Village of Chenequa Plan Commission  
Monday, October 13, 2025 at 6:00 p.m.  
31275 W. County Road K, Chenequa, WI 53029

## STAFF REVIEW

**Project Description:** Proposed Lakeside Landscaping and Shed Relocation

**Project Description:** Proposed Primary Dwelling

GARDEN SHED RELOCATION  
AND WOOD SHED EXTENSION

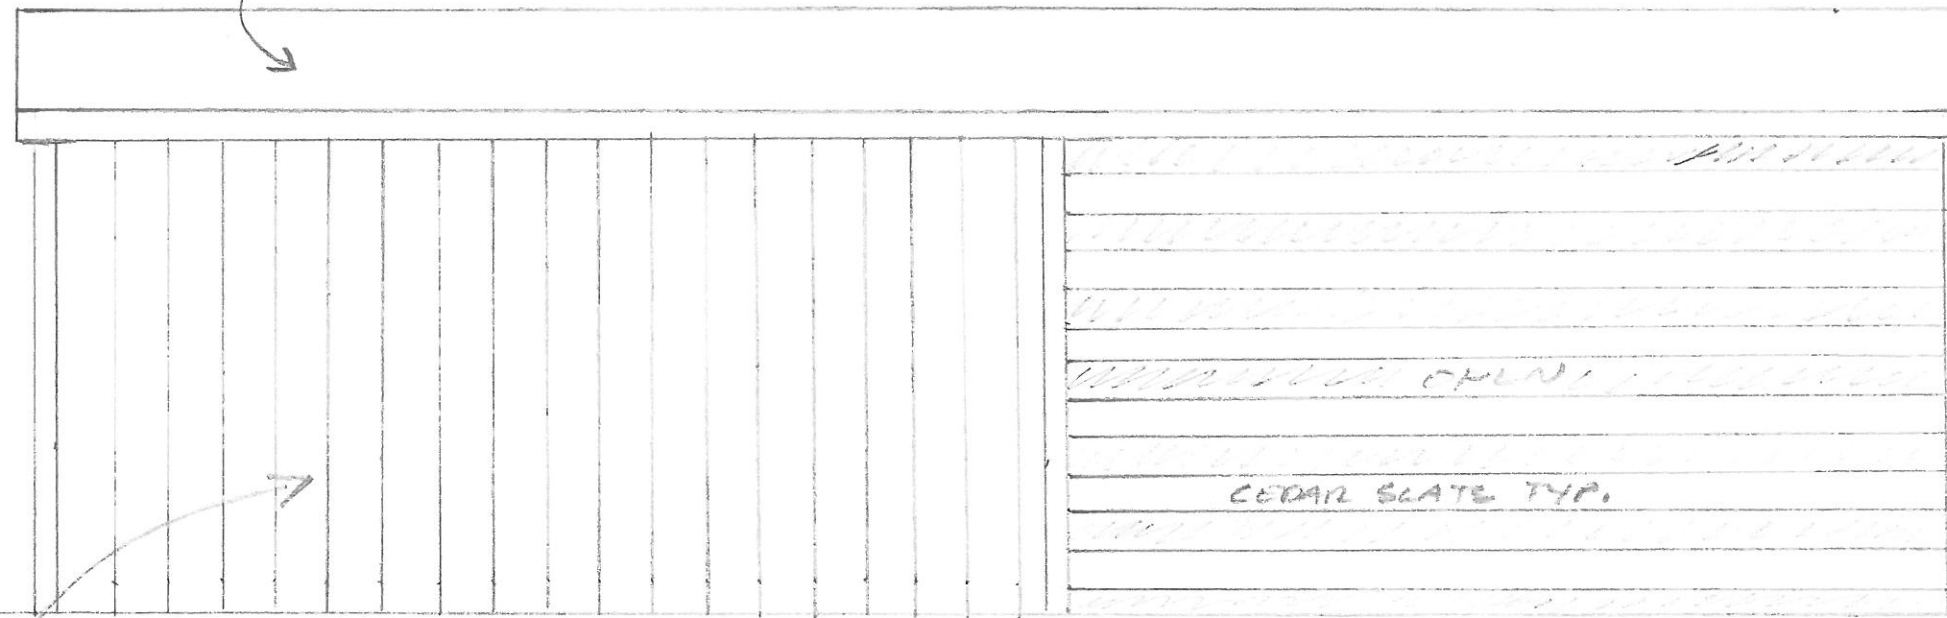
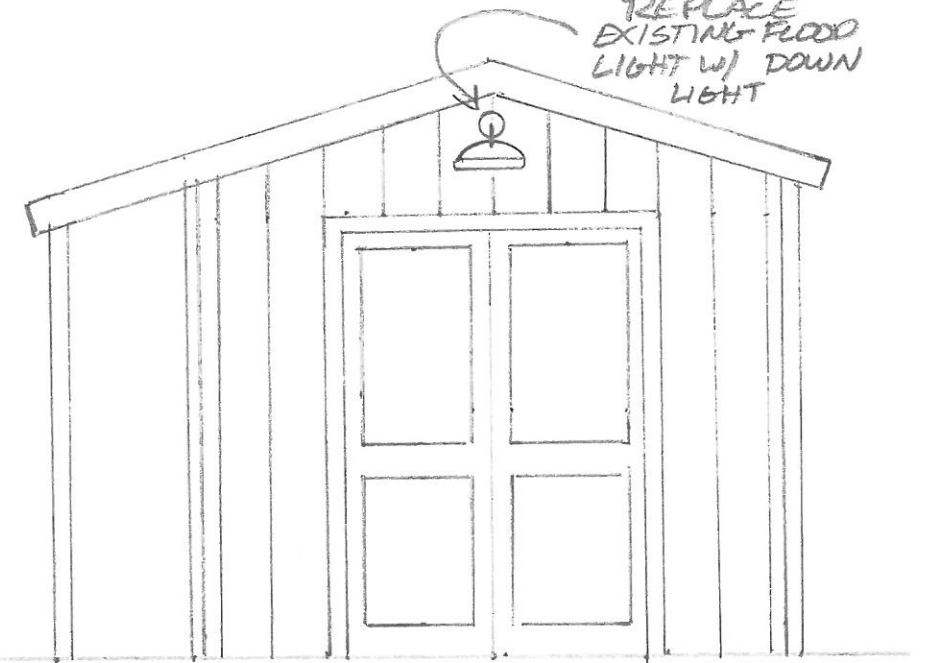
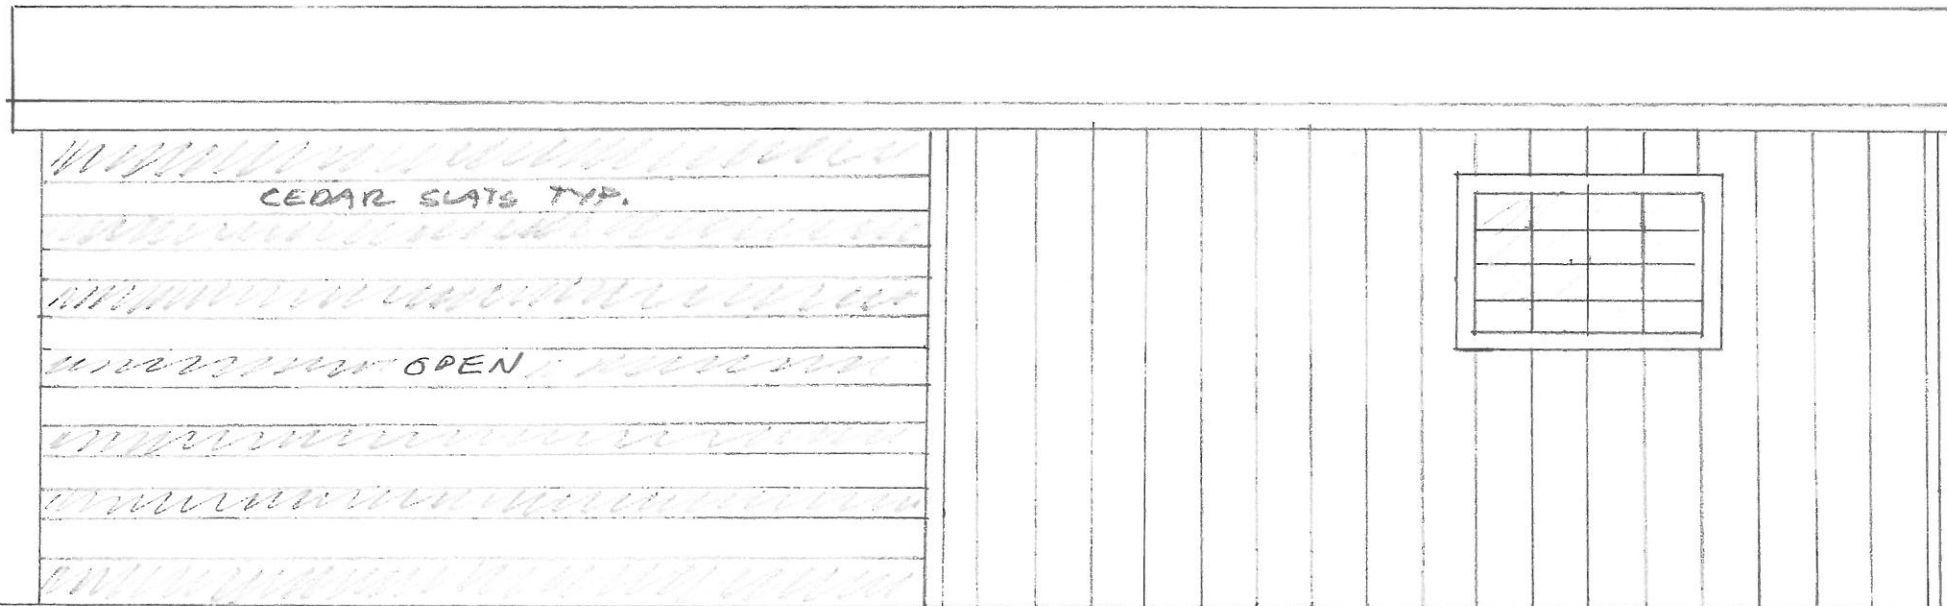
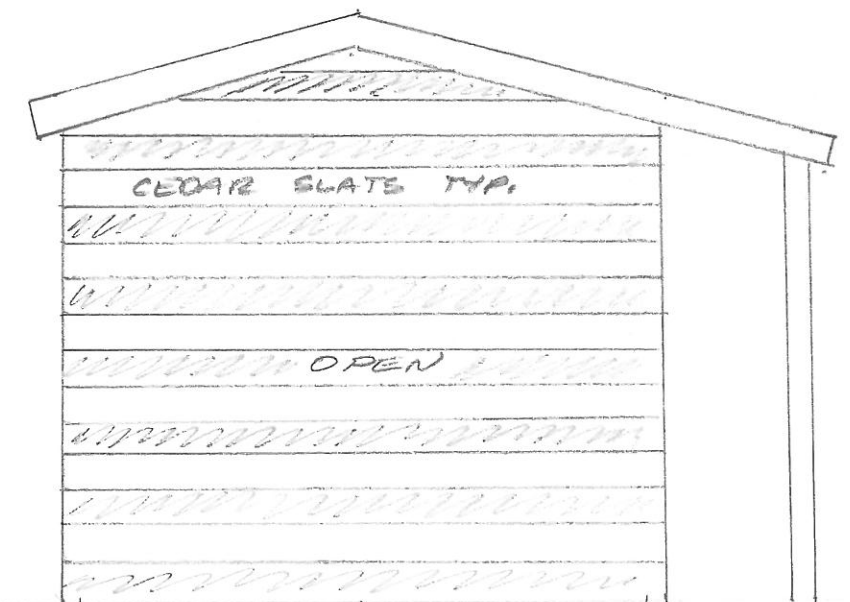
**Proposed Shed Relocation**

- 1. There is an existing shed on the property, the applicants propose to modify the shed and move it to a more suitable location on the property.
  - a. The existing shed dimensions are 10'X14'. The applicants propose to add a firewood shed extension that is 12.5' X 10'
  - b. The site plan included provides photos of the existing shed dimensions
  - c. The site plan also shows the proposed location of the new shed and firewood storage area.
  - d. As proposed, this shed meets all setback requirements specified in chapter 6.
  - e. As proposed, this accessory structure will be 265 square feet, this makes up .2% of the total lot area.

PRELIMINARY LANDSCAPE PLAN

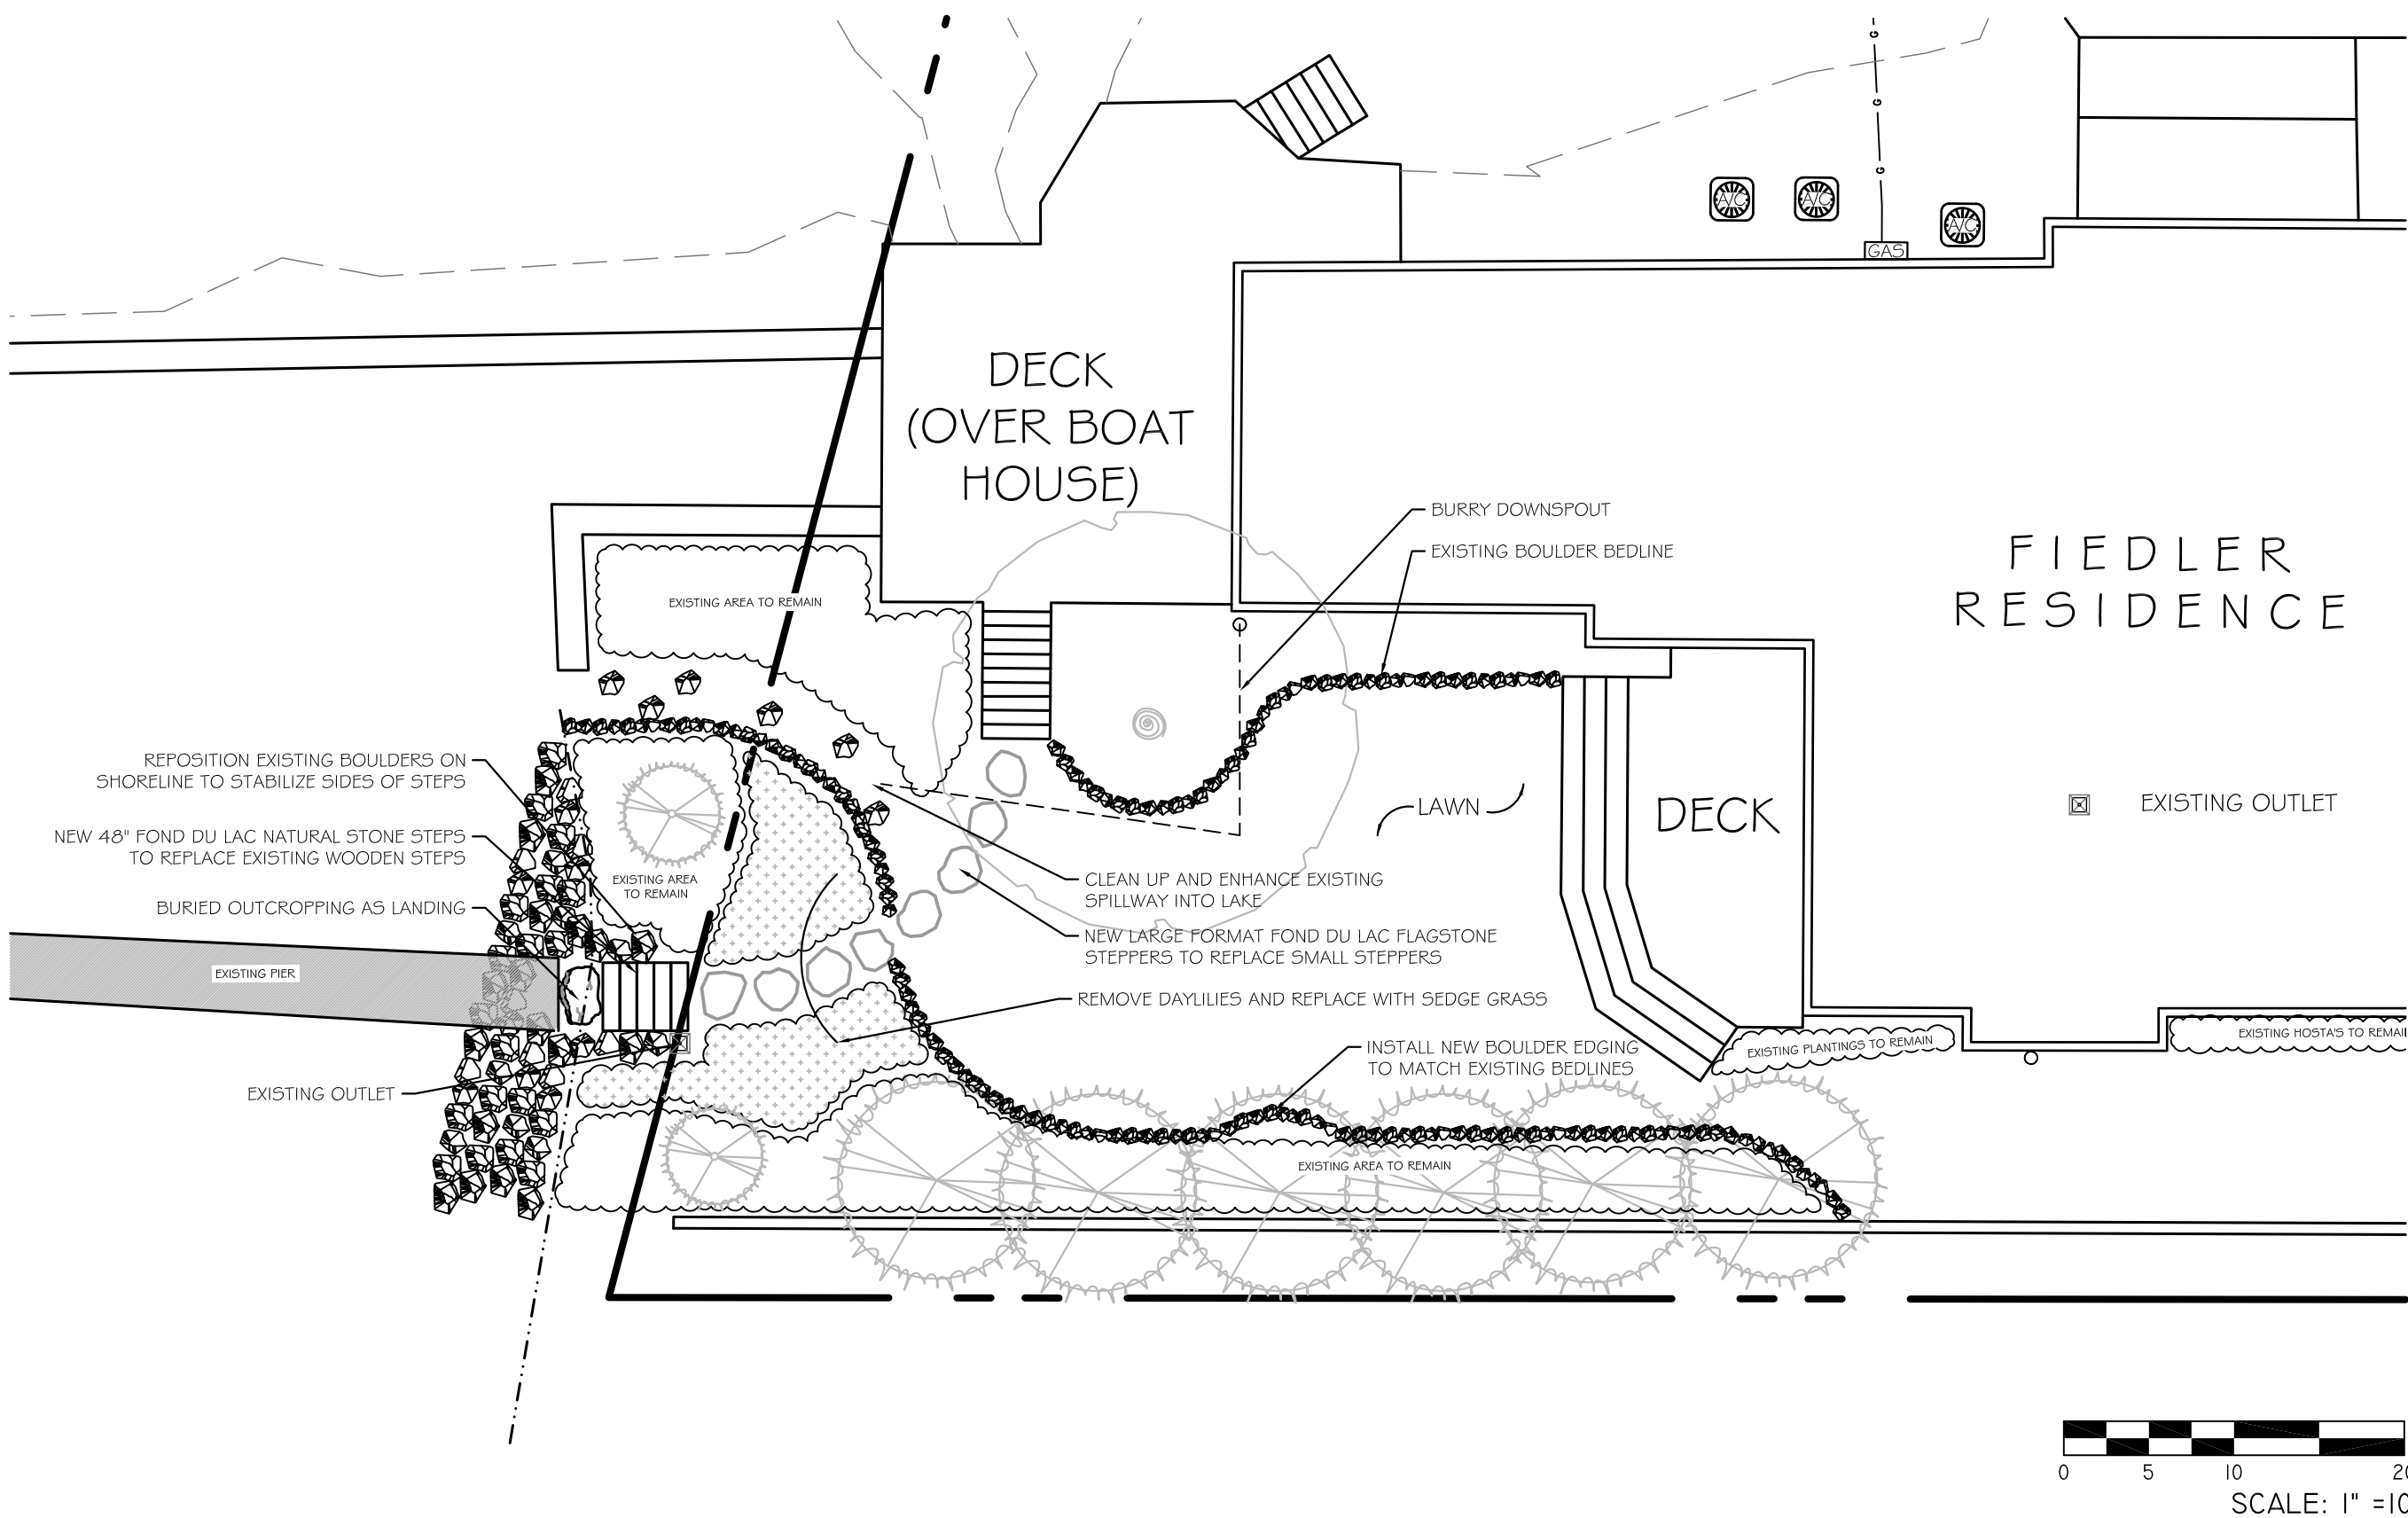
1. The landscape plans include, replacing an existing path/stairs and reworking the planting beds near the shorefront.
  - a. Proposed path
    - i. The new proposed path will follow the same footprint as the existing, but the smaller, random steppers will be replaced with a uniform large stepper as depicted in the landscape plan
    - ii. The path will be constructed of Fond du Lac beige steppers in either mulch or turf.

- iii. The existing pressure treated wood steps and landings will be replaced with 48" natural Fond du Lac beige steps.
- iv. A sample photo of proposed materials has been provided in the packet

a. Planting beds

- i. In addition to the path and steppers, the applicant proposes to rework the existing planting beds.
- ii. This includes;
  - 1. Removing existing daylilies to replace with native sedge grasses
  - 2. Match surrounding planting beds with small fieldstone to be used as a bed edging.
